DATE MAILED: 09/29/2006

Office Action Summary

10/623,355

Fig. 2

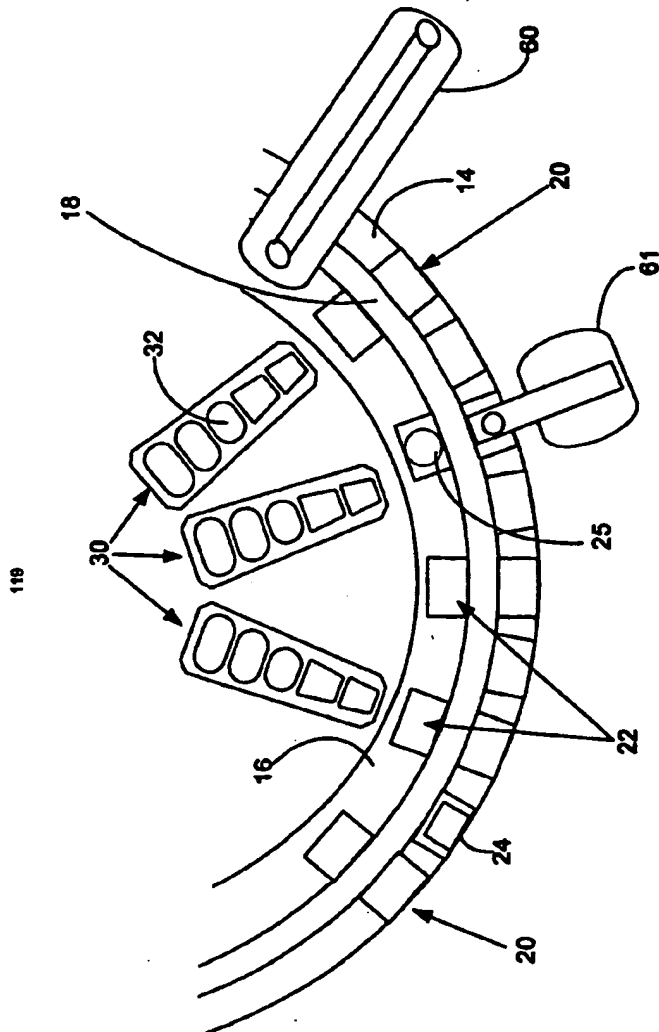
1. Figure 2 should be designated by a legend such as --Prior Art-- because only that which is old is illustrated. See MPEP § 608.02(g). Corrected drawings in compliance with 37 CFR 1.121(d) are required in reply to the Office action to avoid abandonment of the application. The replacement sheet(s) should be labeled "Replacement Sheet" in the page header (as per 37 CFR 1.84(c)) so as not to obstruct any portion of the drawing figures. If the changes are not accepted by the examiner, the applicant will be notified and informed of any required corrective action in the next Office action. The objection to the drawings will not be held in abeyance. Figure 2 is an enlargement of a portion of figure 1 which is prior art. Examiner notes that a replacement sheet was received, however there was no prior art label added. Thus the objection is being maintained.
